**RESPONSE TO
COMMENTS
FOR:**

**THE PINNACLE AT
SERRANO HIGHLANDS**

JUNE 2012

Plant Communities

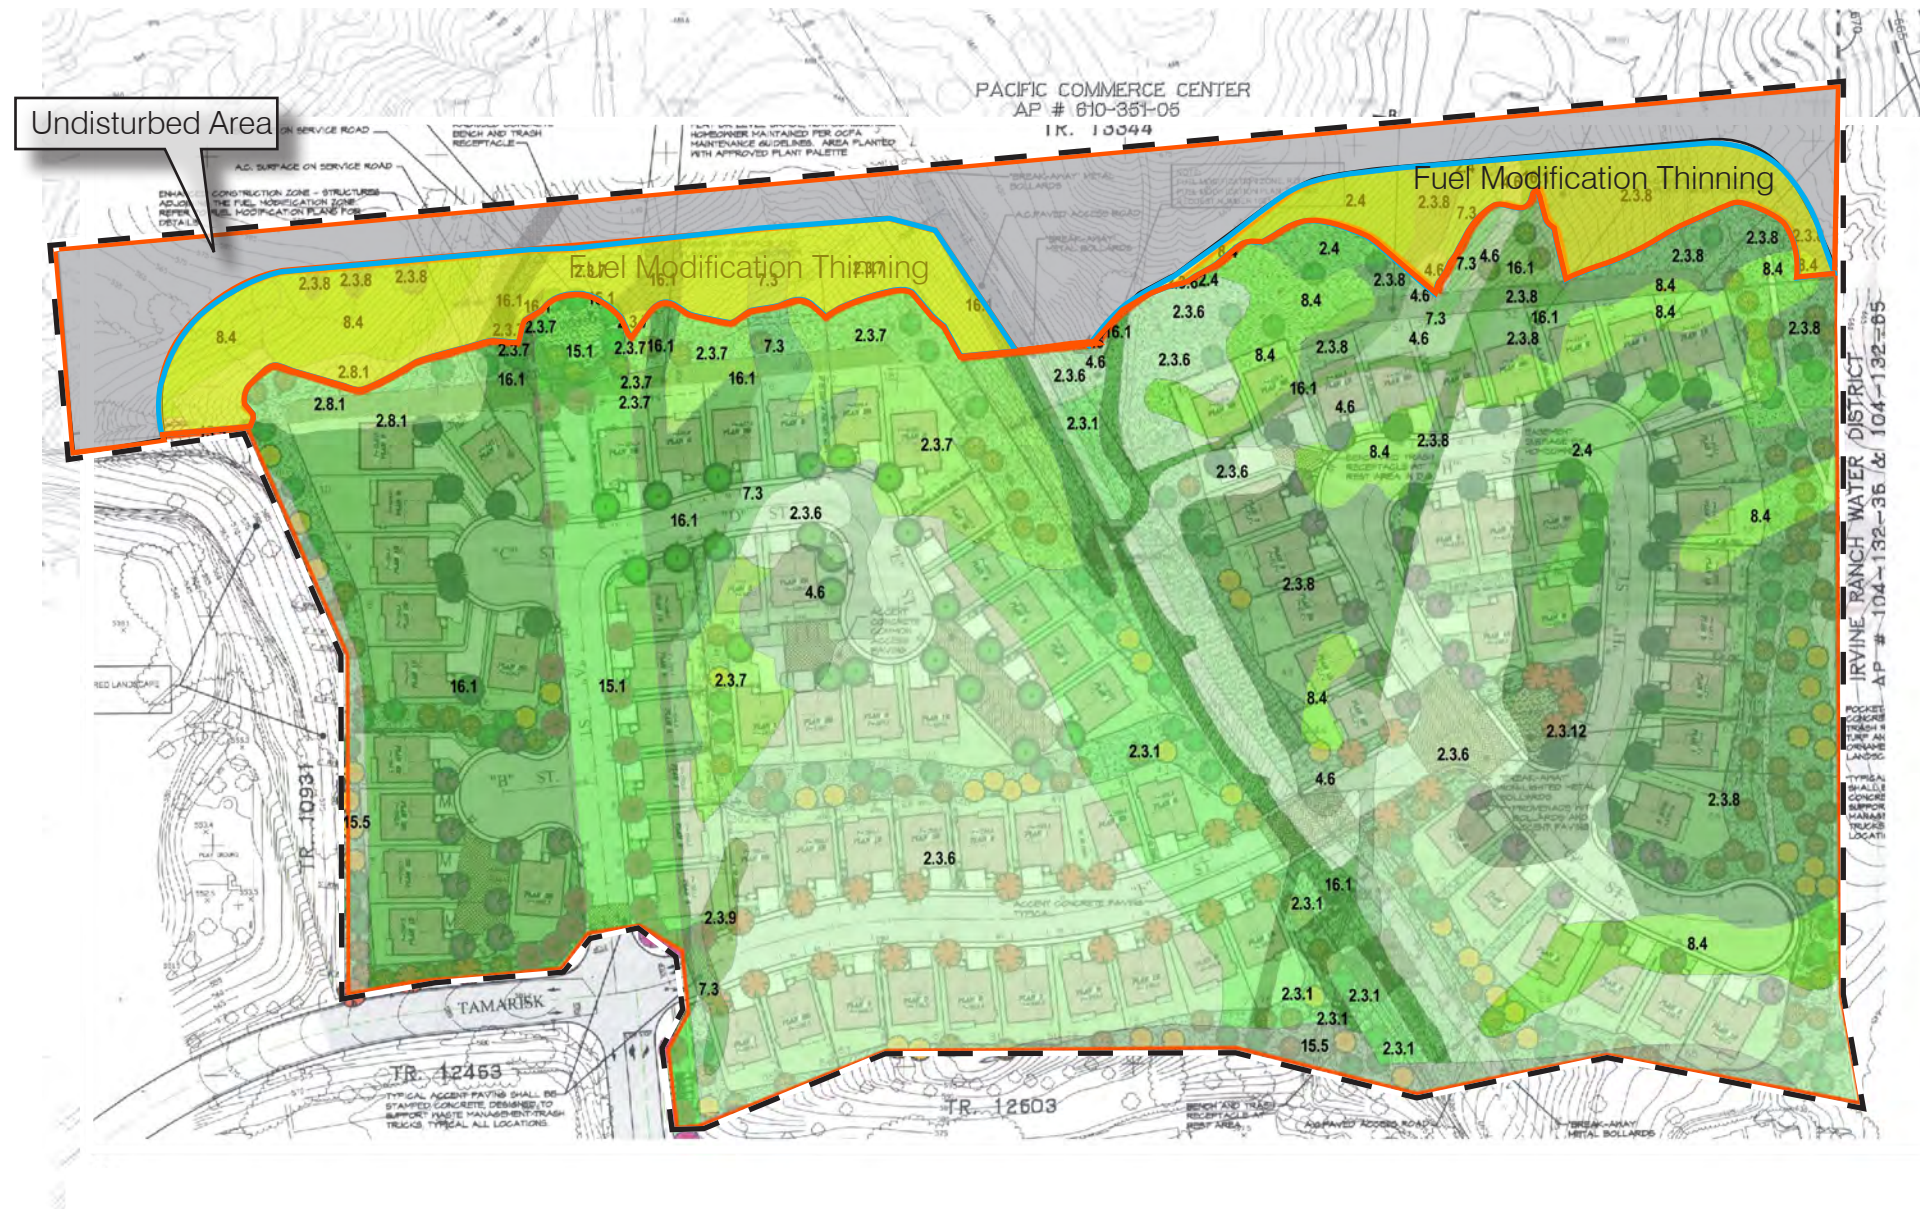
Based on the information provided in the MND, the full extent of project impacts is unclear. Page 72 of the MND indicates there is a total of 21.82 acres of impacts by project development (21.0 acres) and thinning for fuel modification (0.82 acre), and 2.78 acres would remain undisturbed. Appendix B1, B2, and B3 of the MND indicate that the project area is 23.79 acres, including the grading of 19.31 acres and fuel modification on an additional 4.48 acres. Figure 11 indicates that a temporary fuel modification and weed abatement (75-130 feet) zone will be maintained on the adjacent parcel (APN-104-132-36 & 104-132-65). Fuel modifications are expected to result in substantial adverse effects to the remaining habitat both within the project site and potentially extending onto the adjacent parcel. Fuel modifications typically result in substantial degradation of wildlife habitat values associated with coastal sage scrub and native grasslands, even if trees or specific shrubs are retained.

To resolve the above issues, the Department recommends that the final environmental document rectify the above inconsistencies, and identify all (on-site and off-site) impacts from fuel modification as permanent impacts. The proposed permanent habitat removal and/or alteration (e.g., fuel modification) should be mitigated consistent with the requirements of the Central-Coastal NCCP/HCP. Most typically this is performed by payment of an in-lieu fee to the Nature Reserve of Orange County (NROC) at a 2:1 (mitigation-to-impact) ratio.

Subsequent MND Figure 12 has been revised to show the project's boundary in relation to the grading footprint and the fuel modification zone limit. The 2.78 acres outside of the grading footprint and the fuel modification zone limit would remain undisturbed and is not considered impacted. The revised Figure 12 is included in Section 3, *Revisions to the Subsequent MND*.

Subsequent MND Figure 12 has been revised to show the project's boundary in relation to the grading footprint and the fuel modification zone limit.

Figure 3
Existing Through Travel Lanes and Intersection Controls

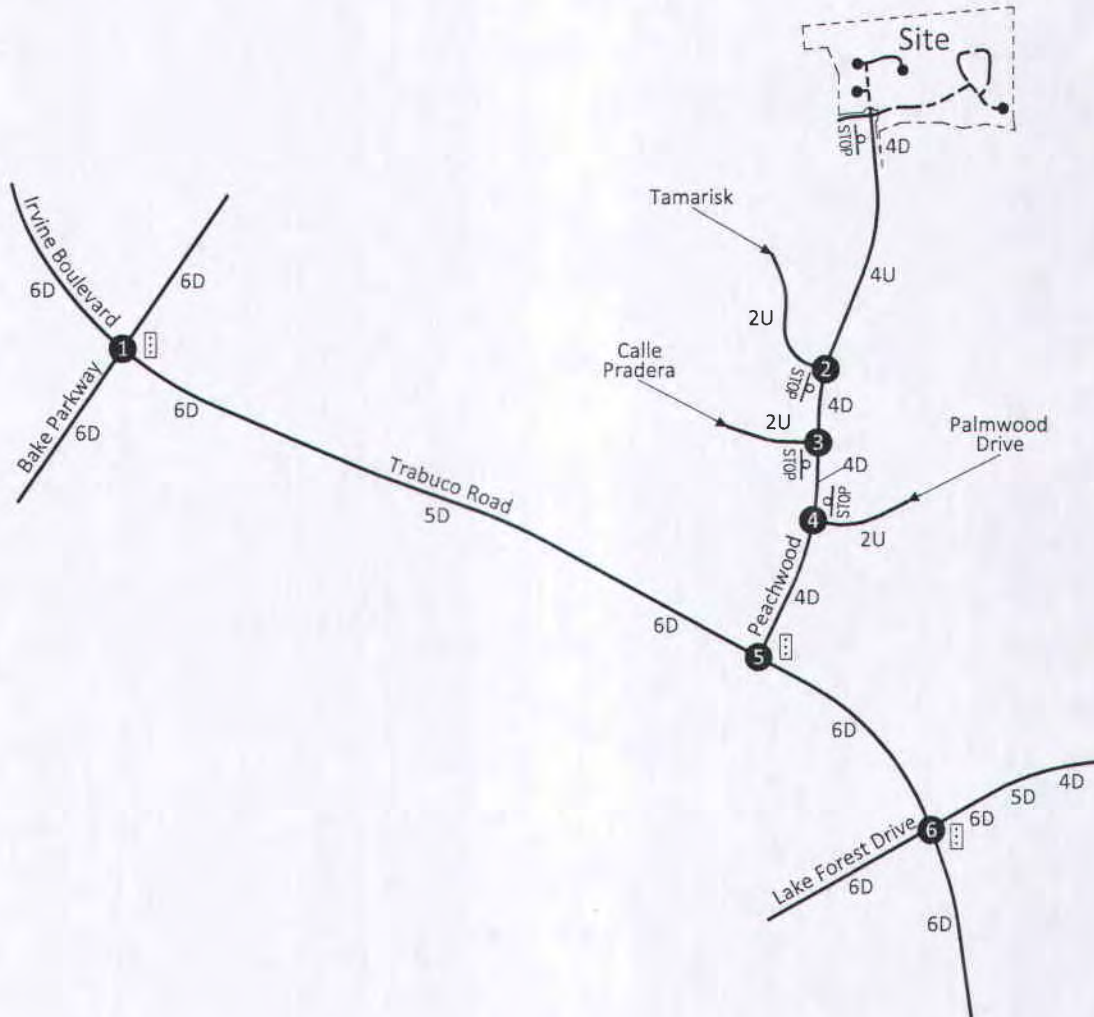
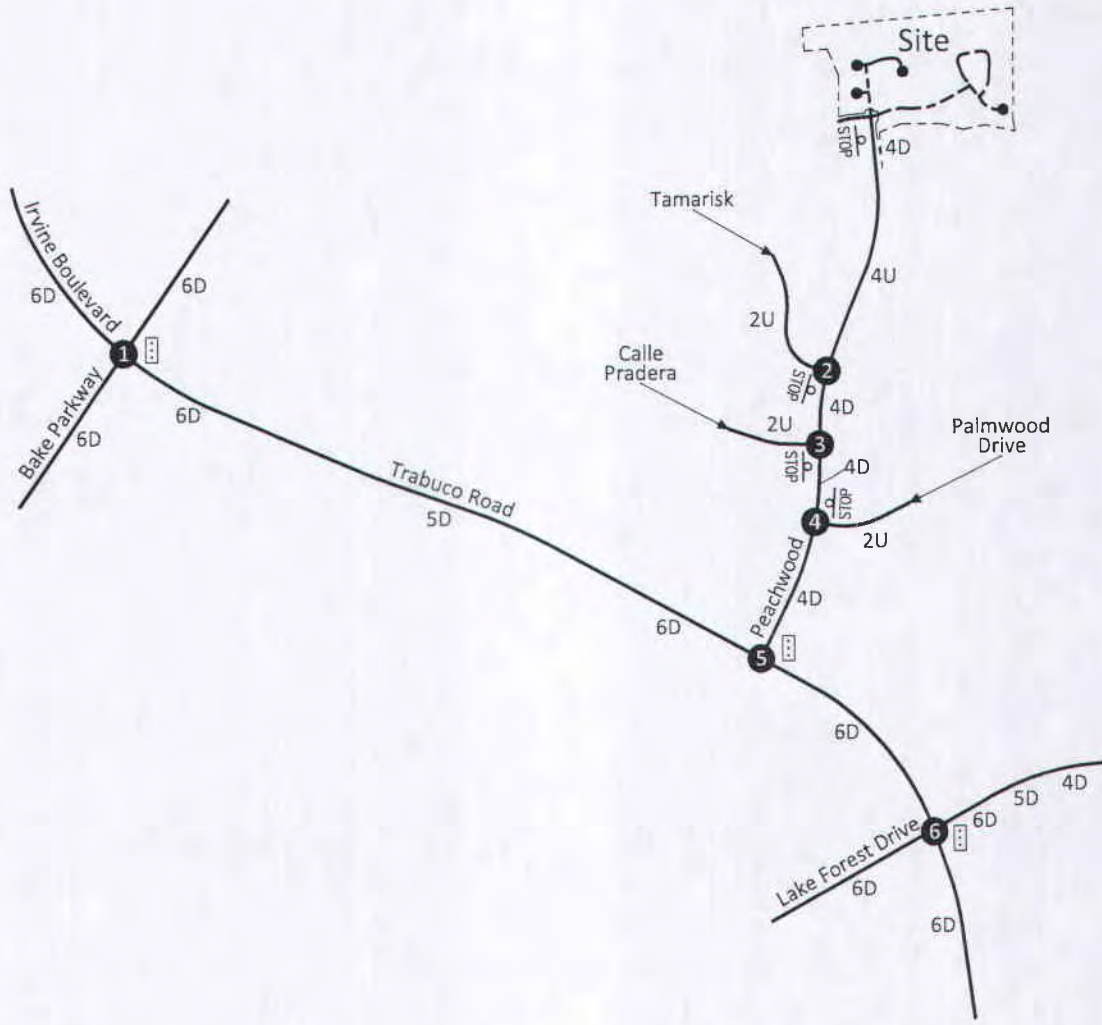
1. Revise the analysis to assume a single northbound left-turn lane on Bake Parkway at Trabuco Road/Irvine Boulevard. The current analysis assumes two lanes in both the existing and 2015 analysis.

A1-1 The analysis has been revised to assume a single northbound left turn lane at the intersection of Bake Parkway and Trabuco Road/Irvine Boulevard. The updated analysis is dated April 16, 2012. It should be noted that this intersection geometric change did not change any Level of Service letter grade or any Intersection Capacity Utilization value. The revised portions of the traffic analysis can be found in Appendix A of this document. Traffic impacts remain less than significant as reported in the circulated Subsequent MND.
